SUBJECT: Coastside Design Review  
The Alameda, El Granada  
APN 047-234-220; County File No. PLN 2015-00416

At its meeting of September 8, 2016, the San Mateo County Coastside Design Review Committee (CDRC) considered your application for design review approval to allow construction of a new 2,673 sq. ft. two-story single-family residence plus an attached 481 sq. ft., two-car garage on a 6,273 sq. ft. legal parcel. Eleven (11) trees are proposed for removal.

**SUBJECT :** Coastside Design Review  
The Alameda, El Granada  
APN 047-234-220; County File No. **PLN 2015-00416**

**SITE PLAN**

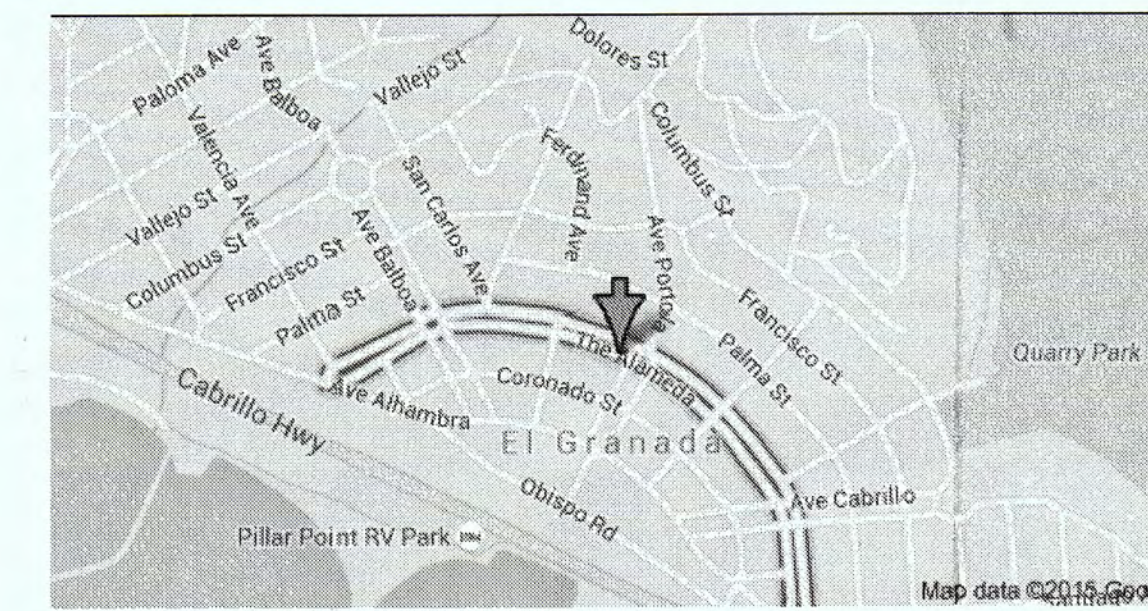
6. Indicate on plans and elevations all proposed downward-directed exterior lighting fixtures.
7. Indicate on plans and elevations any proposed fencing including details such as height, location, color, materials and style.
8. Submit manufacturer's specification sheets (cut sheets) that indicate Dark Sky compliance for all proposed downward directed lighting fixtures.
9. Submit original manufacturer's color chips for all proposed project colors.
10. Submit a detailed landscape that includes shrubs and ground cover.
11. Revise the material for the driveway and rear patio to permeable pavers (pavers) and submit manufacturer's specifications sheets (cut sheets) for these pavers.

11. Please see revised Site Plan specifying that the driveway shall be of permeable paver materials.

LEFT-SIDE ELEVATION  
1/4" = 1'-0"

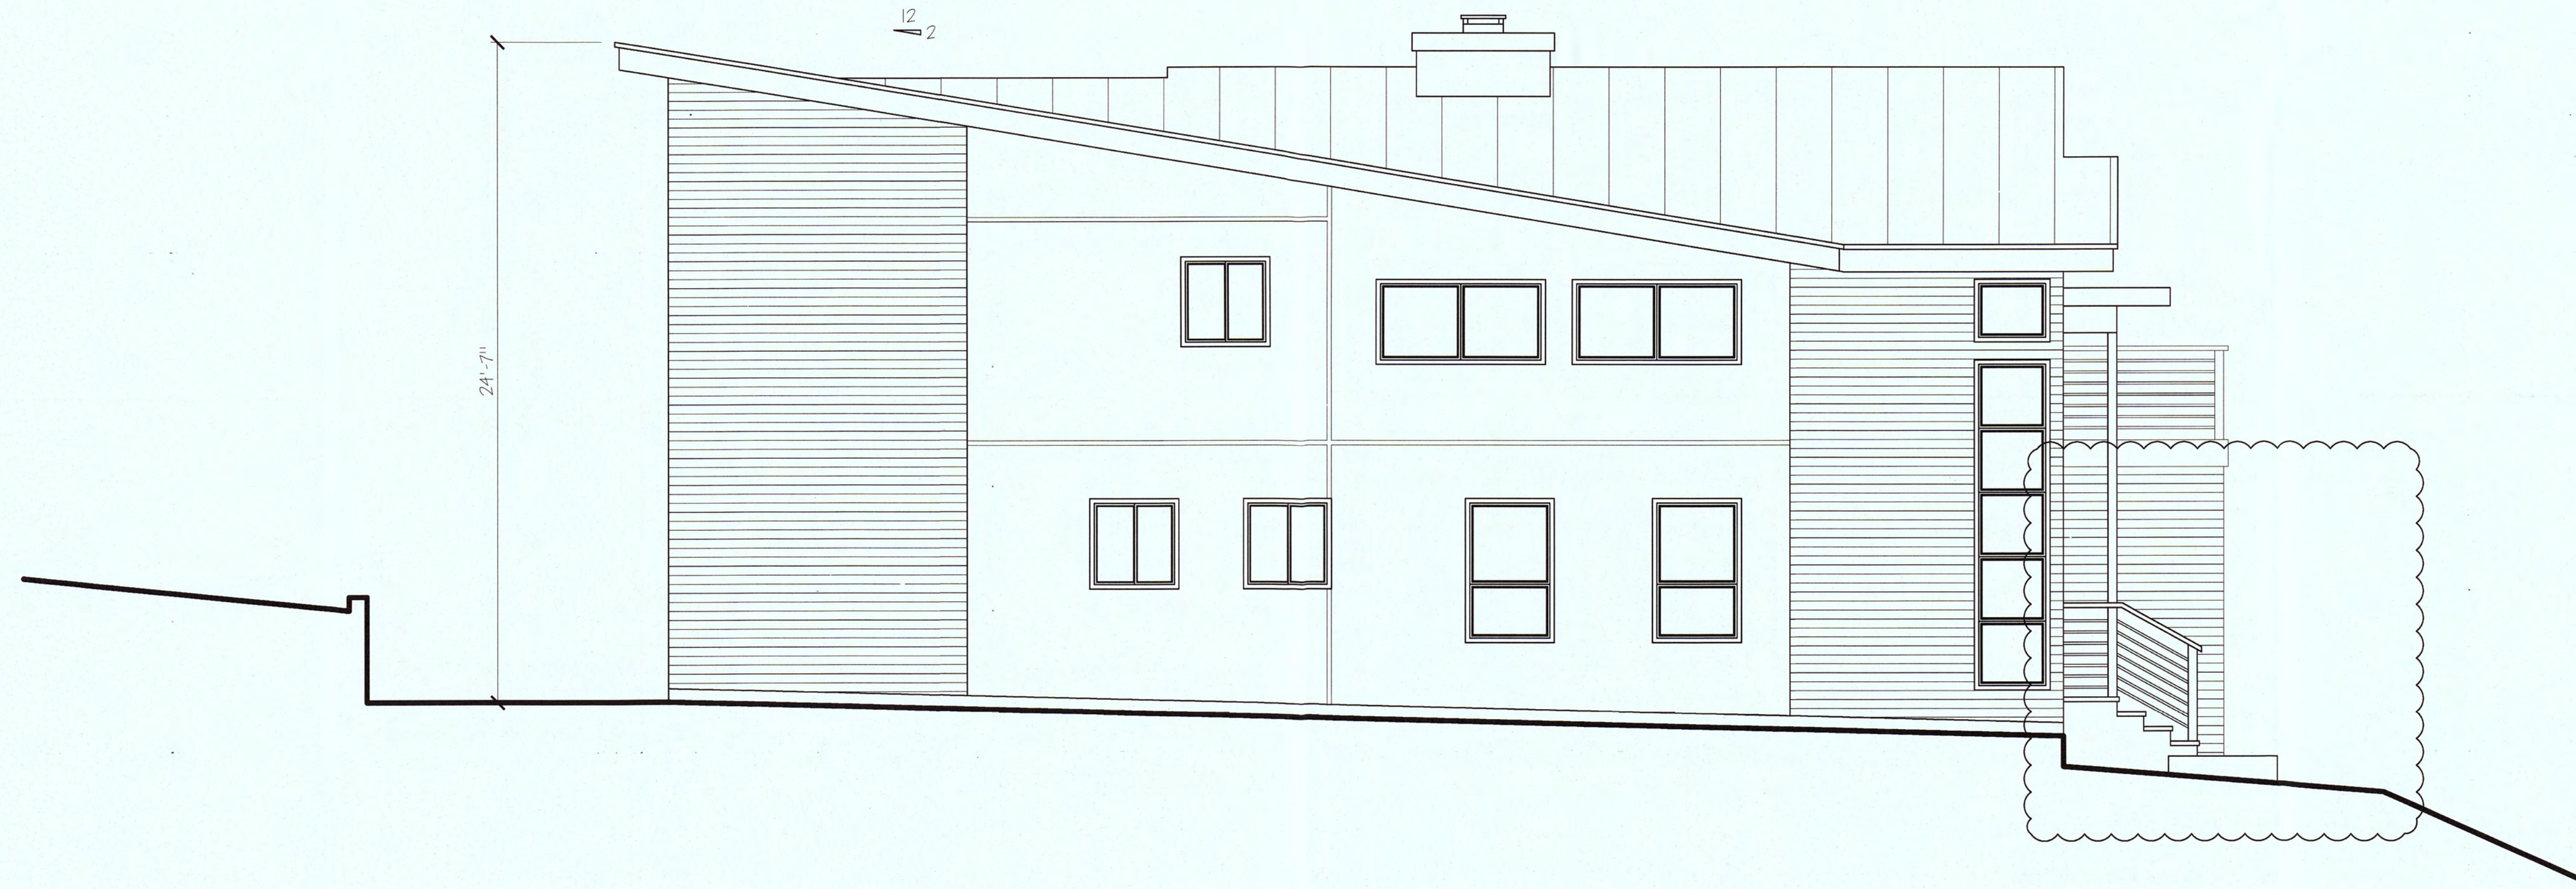
1. Redesign the front entrance to be lower than the interior staircase.
2. Refine the window orientation at the left elevation.
3. Add articulation and massing at the left elevation, and if feasible, include wood at the corner of the front stairs.
4. Clarify and further articulate the stucco breaks.

1. Please see revised drawings, front entrance is redesigned to be lower than the exterior staircase. As recommended.
2. Please see revised drawings, window orientation is now refined to have two large windows in the dining area and two tall windows below for the bedroom.
3. Please see revised drawings, wood siding is now added on the left-side elevation of the house.
4. Please see revised drawings for the recommended stucco breaks locations.
